The State of New Hampshire  
**DEPARTMENT OF ENVIRONMENTAL SERVICES**

Subject: Portsmouth – Former Country Motor Sales, 375 Banfield Road  
DES Site #199408047, Project #40176

*Supplemental Site Investigation Report*, prepared by Wilcox & Barton, Inc. (Wilcox & Barton), dated November 22, 2021

**RE: 0 Borthwick Ave**  
**Meeting: TAC 04-05-22**

**P0616-005\_Post**

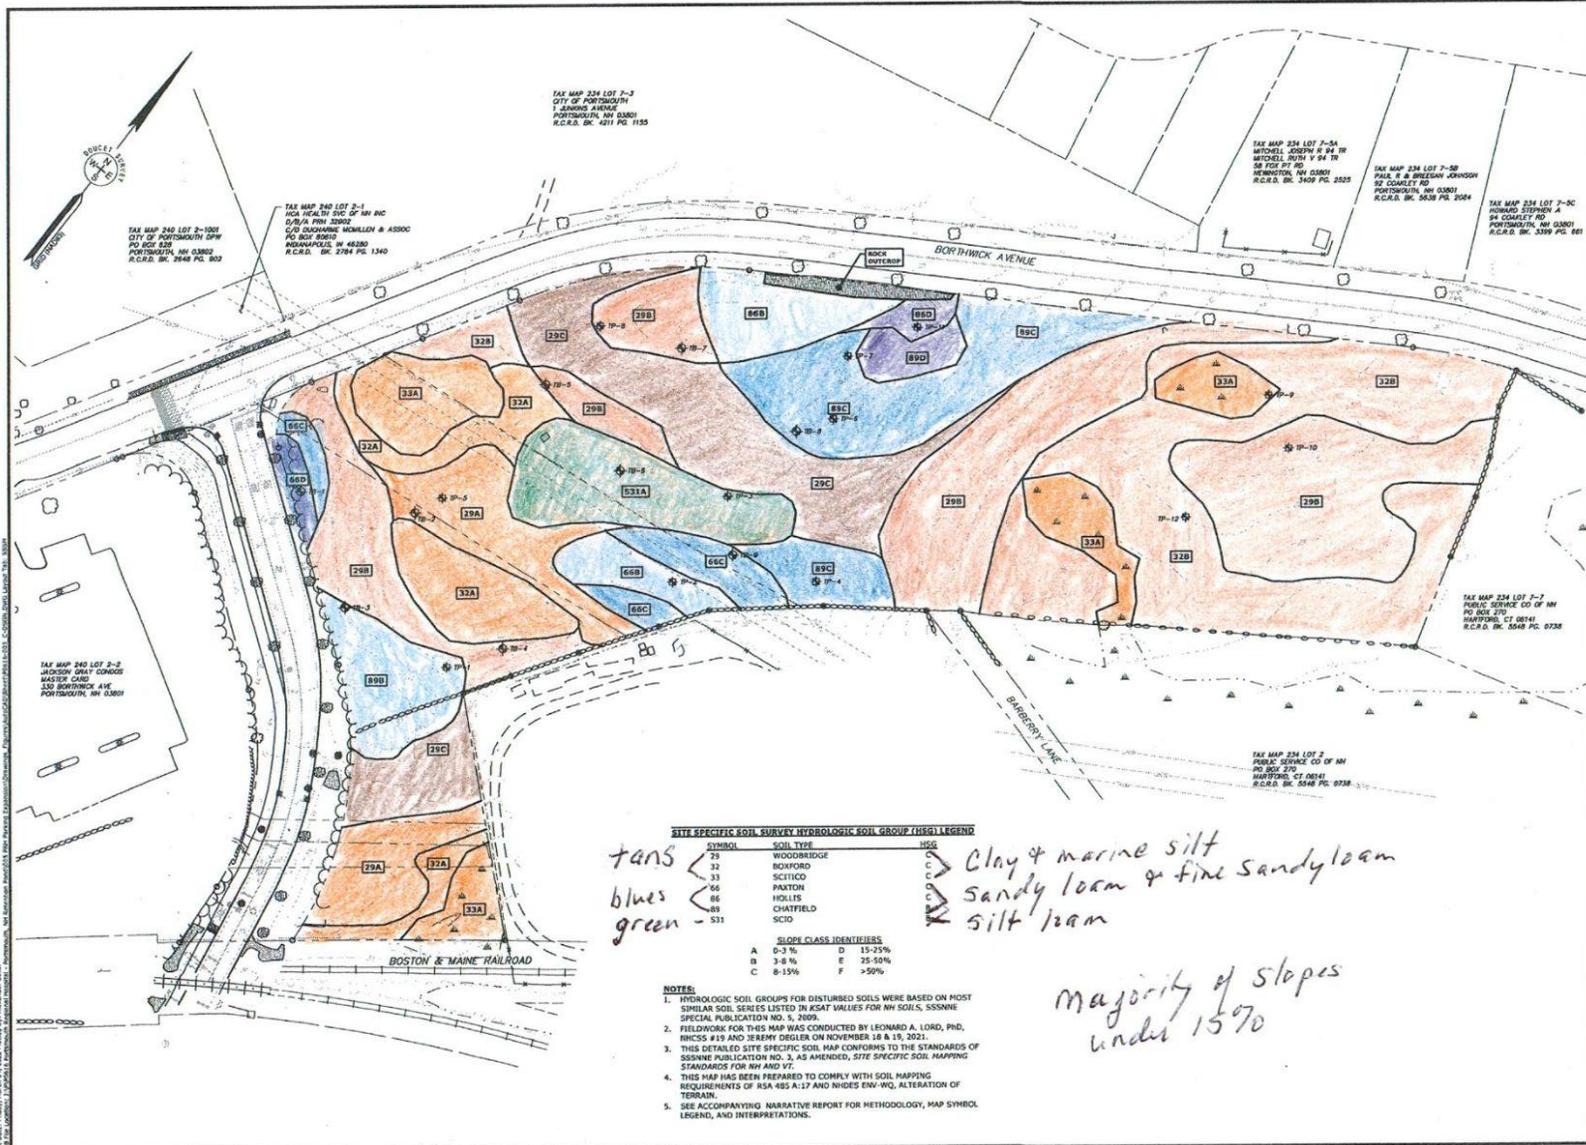
It can be appreciated that the proposal seems to respect the 100' wetland buffer on the rear of the property by *not building on it*. However, the amount of unnatural run-off will likely have a negative impact on this highly functional wetland. Section 2 (2-1 drainage analysis) shows existing curve numbers(CN) of 65 and 68 (range 30 to 100) as well as established trees and thick underbrush all parts of a balanced wetland system. **How many other new developments in that area have added or are planning on adding their run off to these valuable wetlands?**

Looking at the "Site Specific Soil Plan" (colored graphic at end) the majority of the soil on this property is clay and marine silt (tans) It shows silt loam(green) in the middle of the proposed parking lot. The land is relatively flat with most slopes in the 0-8% range and the majority under 15%. Section 3 (3.1 drainage analysis) states the detention system will drain down at longer than 24 hours. However, looking at the majority of soil on this land (clay, marine silt) under existing conditions, drainage based on CECs could take a long time to clear a single rainfall event. **The capacity of the underground retention systems is the concern.** It does not seem to decrease existing drainage but seems to increase drainage into the wetlands at a far greater rate than currently exist. The "post" curve number average is 79.4 (range 30-100), some of post CN are in the 90s comparing the 2 year pre and post conditions (included at end). Flows greater than the 2 year storm events will bypass the treatment units. Based on normal New England weather it seems a lot of the water will go untreated into the wetland at a much higher rate than existing which was filtered through trees, brushes, grasses and slowly absorbed by clay and marine silt. *Does this meet MS4 regulations?*

Section 4 (4-3 drainage analysis) states "the post-development flows have been minimized to the greatest **extent practical**." Walking through the current PRH parking lot on any rainy day one can experience practical vs what is really necessary by wading through LARGE puddles to get to the building. The placement of sidewalks as well as raised planting islands just add to the water issues. The systems should reflect what is "really" necessary and not be allowed to pour untreated water directly into wetlands after typical NE high rain events. It seems expected 2 yr events will overflow unfiltered right off the bat.
